ADDENDUM NUMBER 2

- 1.01 DATE: NOVEMBER 23, 2020**
- 1.02 PROJECT: ELMORE SPORTS MEDICINE RENOVATIONS**
- 1.03 PROJECT NUMBER: DCM NO. 2020452**
- 1.04 OWNER: ALABAMA A&M UNIVERSITY**
- 1.05 ARCHITECT: NOLA | VAN PEURSEM ARCHITECTS, PC**

3 BUILDING SECTION
A-3.2 SCALE: 1/4" = 1'-0"

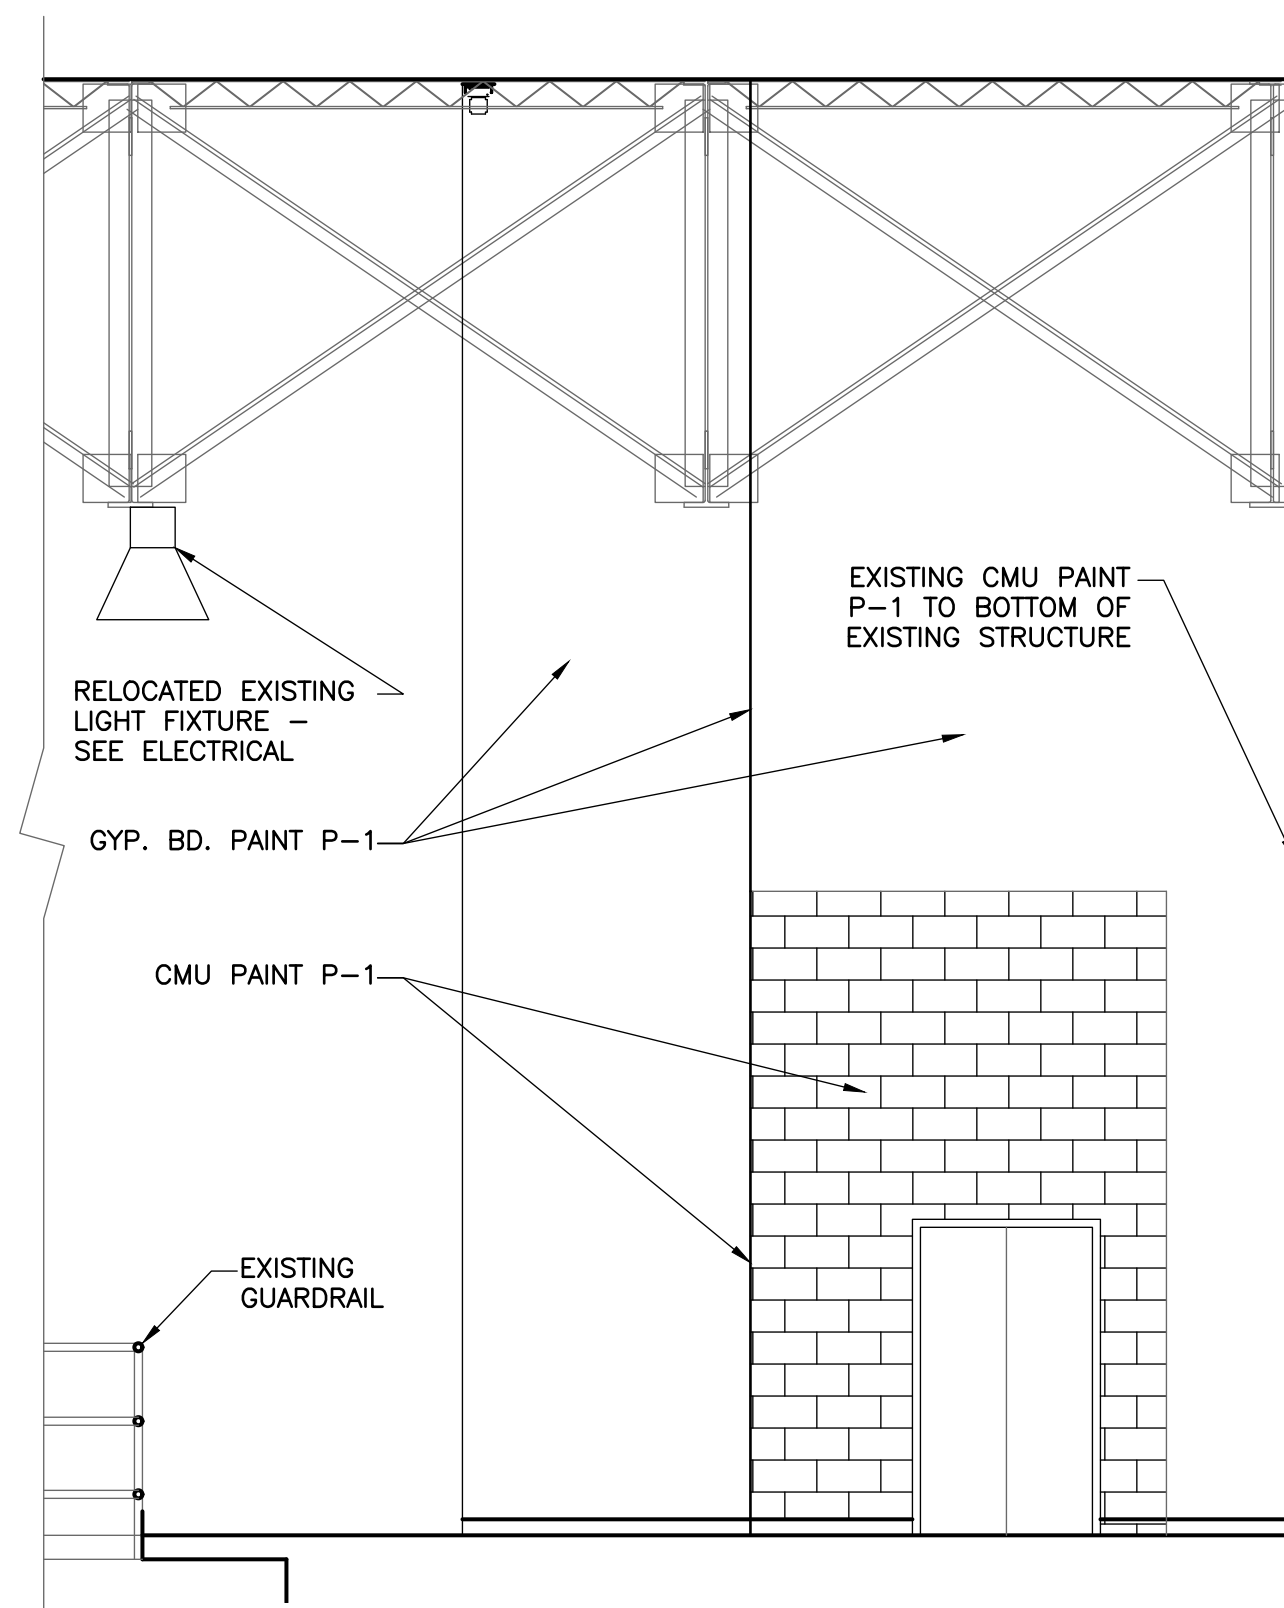
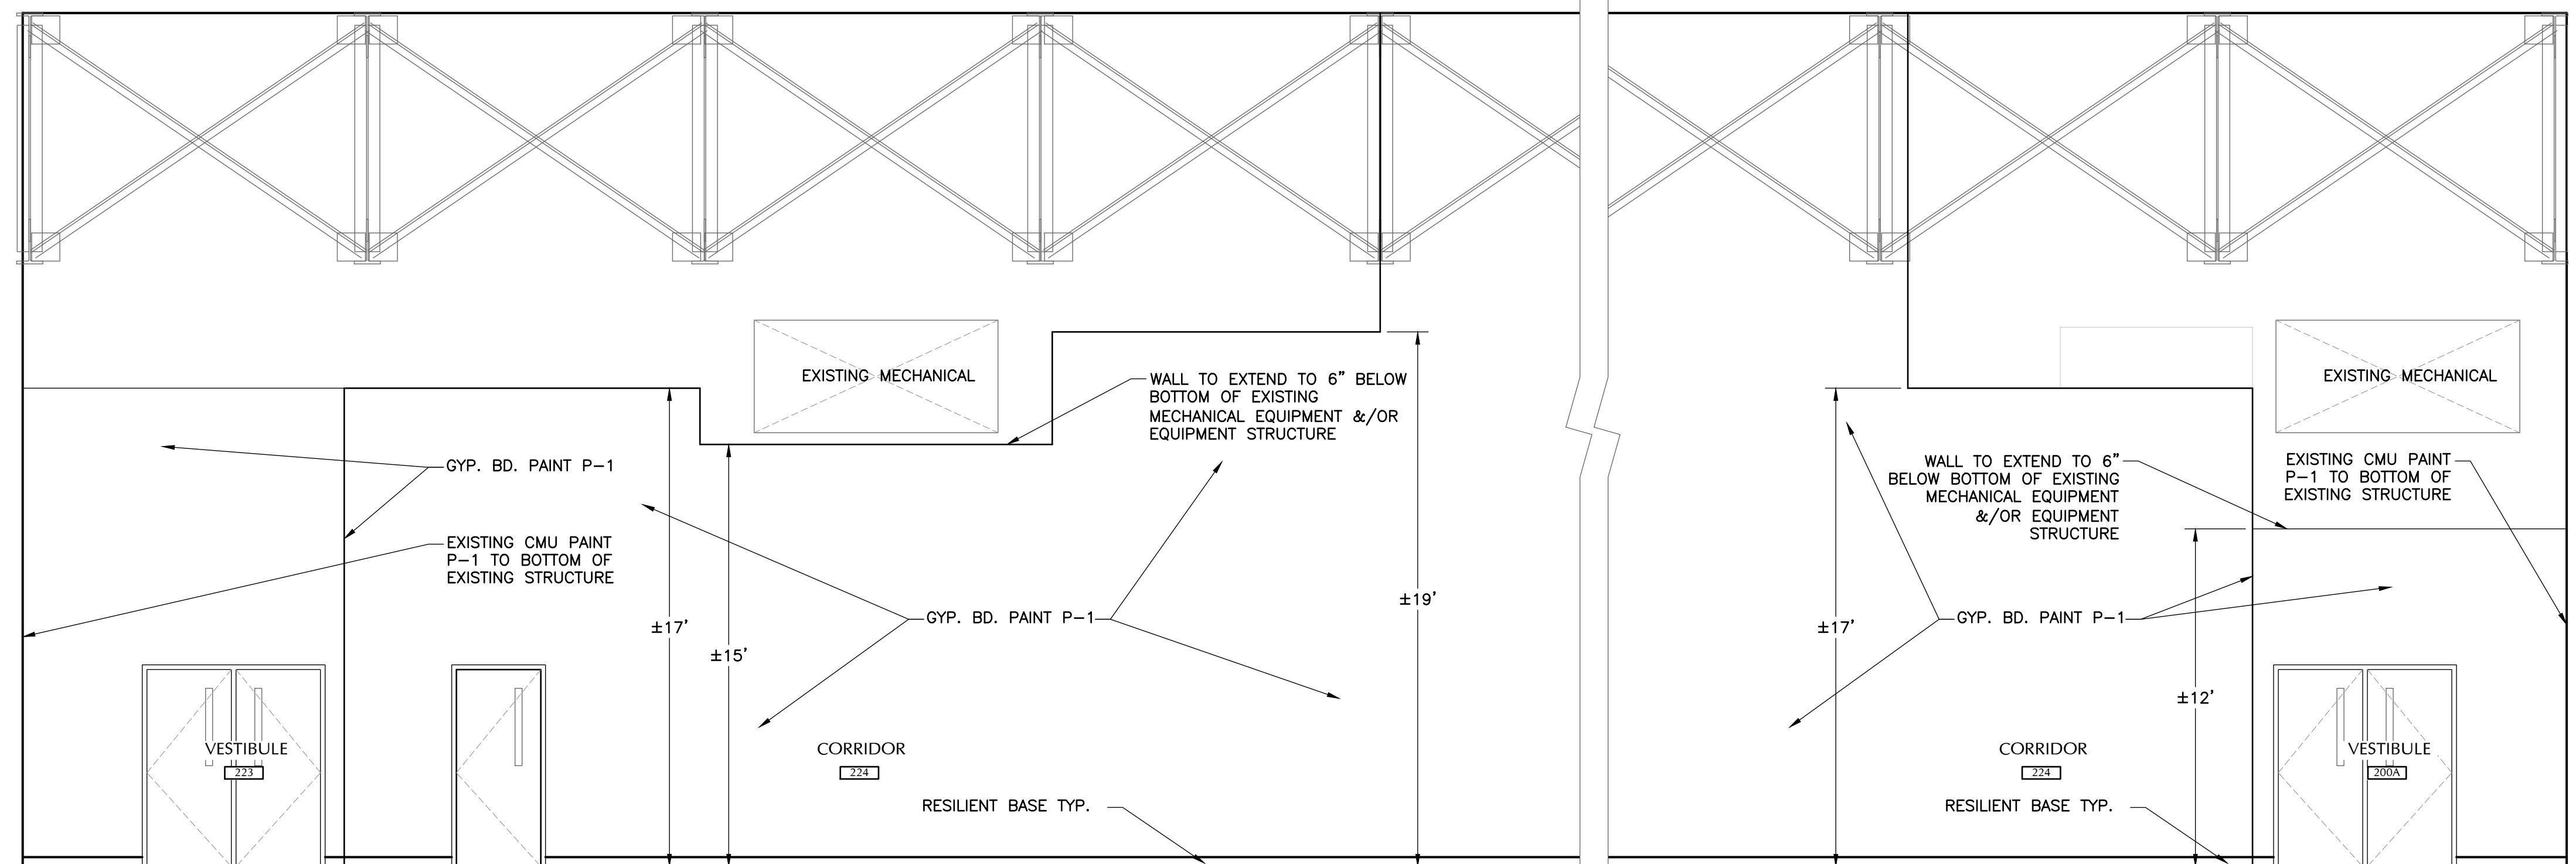
- A. Replace this sheet in its entirety. Revisions include the following:
 - 1. Added acoustical ceiling to portion of sports medicine training area.
 - 2. Added attachment note to typical steel ladder detail.

2 ELEVATOR SECTION
A-3.3 SCALE: 1/4" = 1'-0"

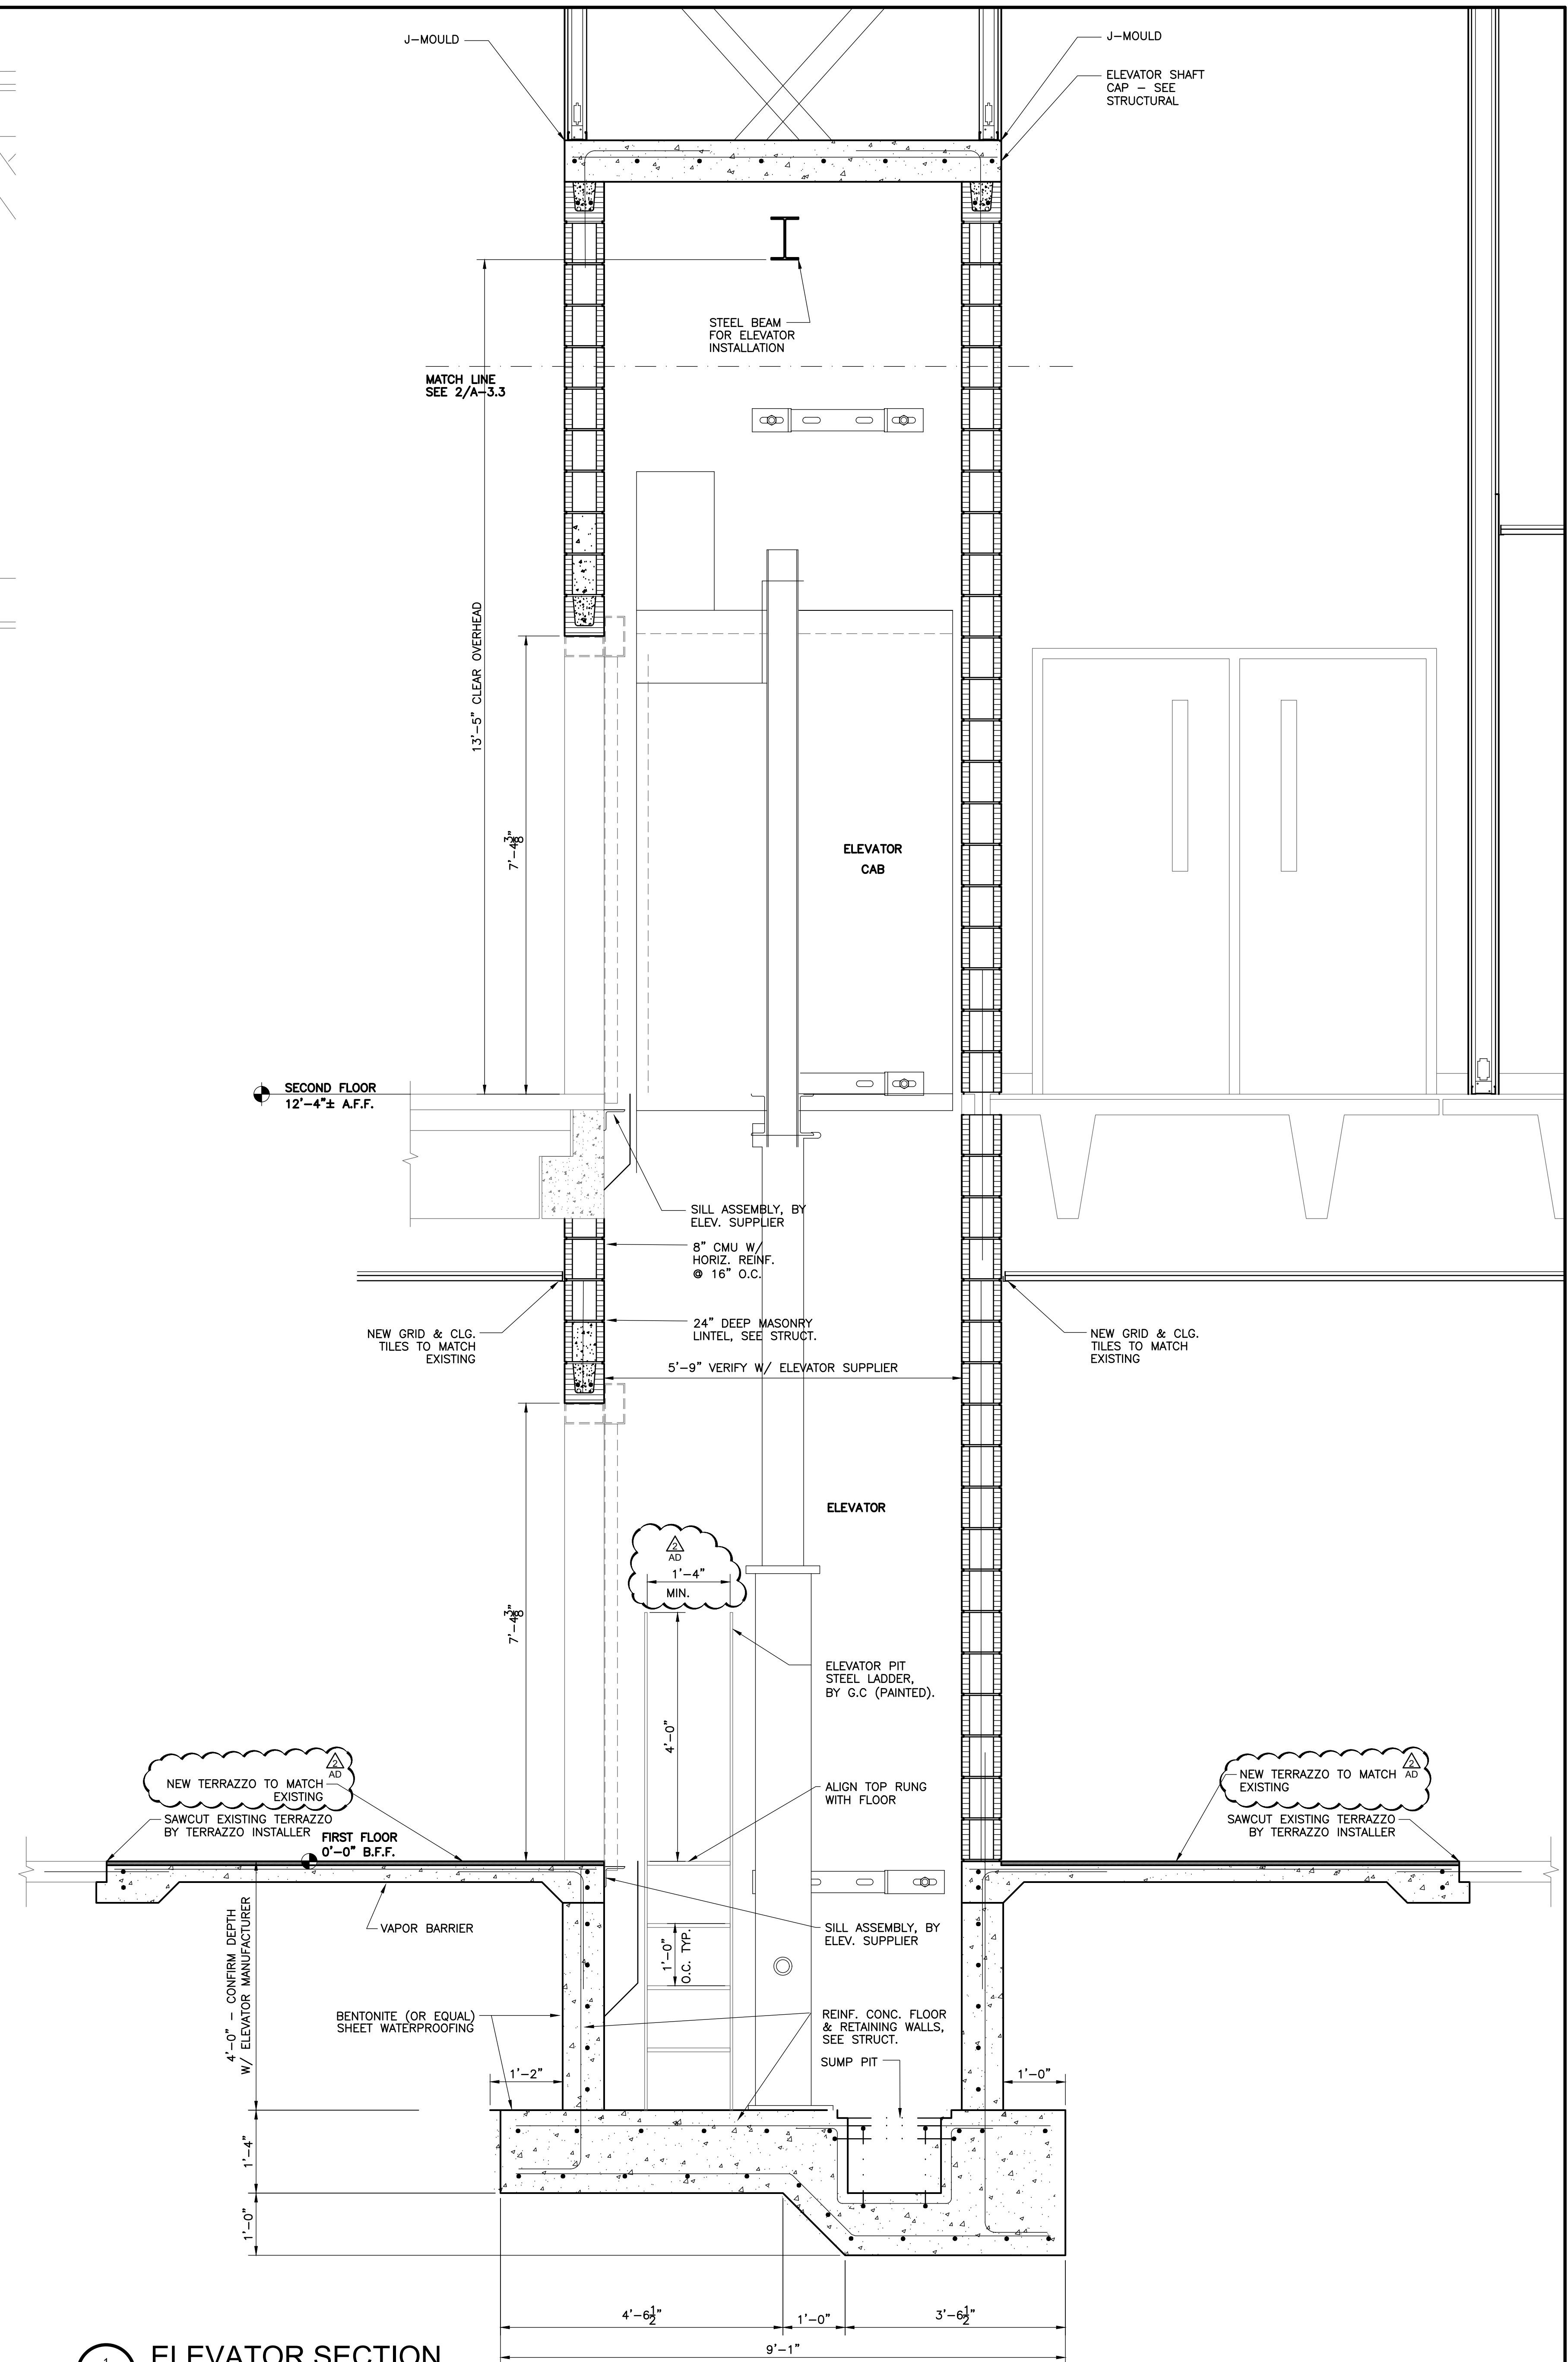
- A. Replace this sheet in its entirety. Revisions include the following:
 - 1. Revised elevator pit ladder width.
 - 2. Added high ceiling at elevator section 2/A-3.3.
 - 3. Added new terrazzo detail note.
